SERVICE SLANTS

ISSUED BY WURLITZER SERVICE DEPT., NORTH TONAWANDA, N. Y.

Selector Coil and Selector Latch Pin Replacement Models 1500 and 1550

FIG. 1

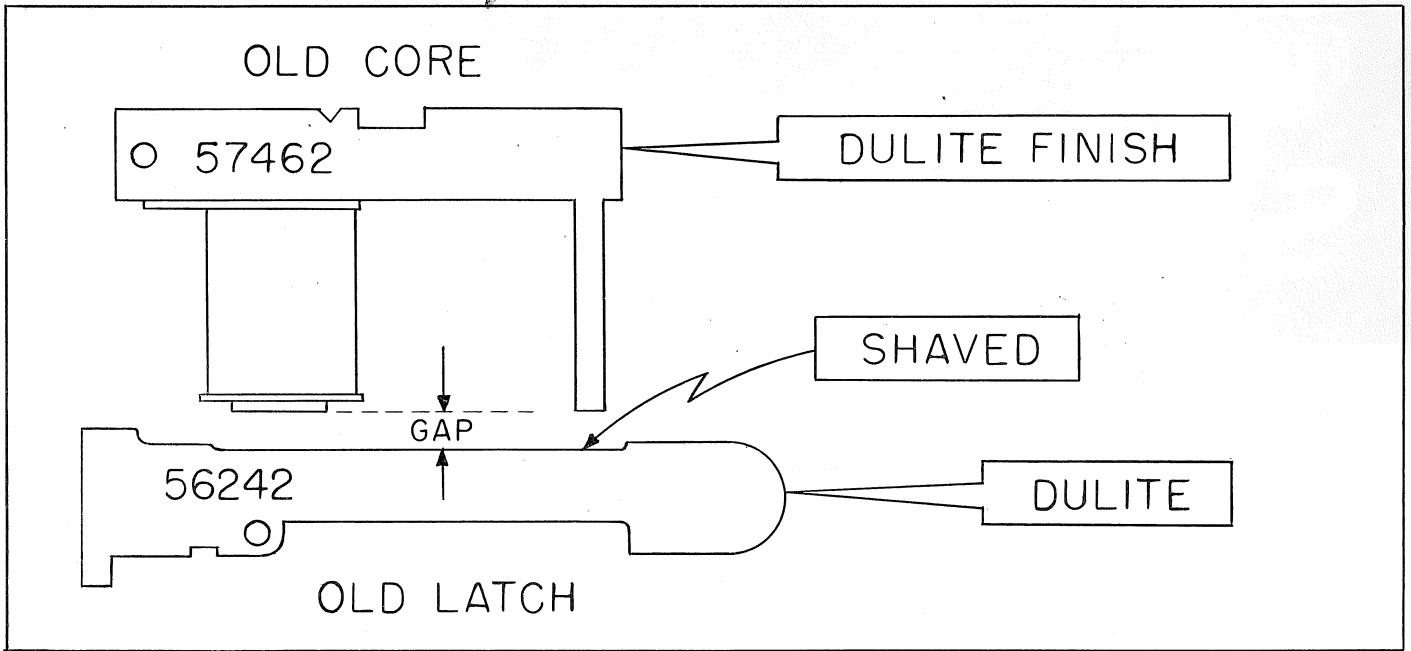
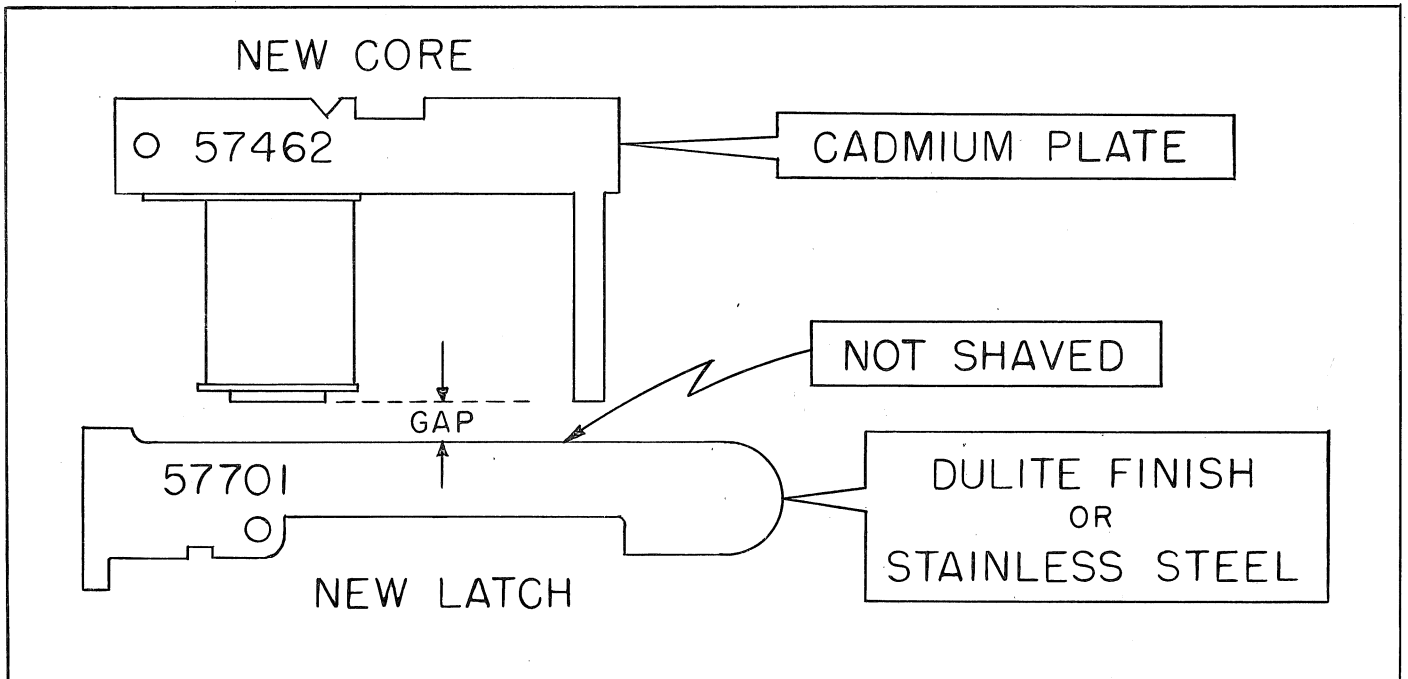
2. a. Earlier selector assemblies were made up of coil assemblies with long cores and latch pins shaved, as in Fig. 1, to provide clearance.
b. In the case described in "a." both parts were finished in dulite (black finish). They were supplied under part numbers 57462 and 56242 respectively.

3. a. Later selector assemblies (Approximately Oct. 15, 1952) were made up of the selector coil and core (Part No. 57462 - Issue 2) which has a shorter core than the earlier assemblies. This type assembly may be identified by its cadmium plating.

b. As the air gap has been provided by the shorter core - the latch pin will be straight as indicated in Fig. 2, with no shaved edge. It will be supplied either in dulite finish or stainless steel under part number 57701.

4. A long core must be accompanied by a shaved latch pin. A short core must be accompanied by a straight latch pin.
5. In ordering replacement parts for selector coils use part number 57462 for the coil and core assembly. This assembly is staked together and is not broken down further. Use part number 57701 for latch pin to match the 57462 coil and core assembly.
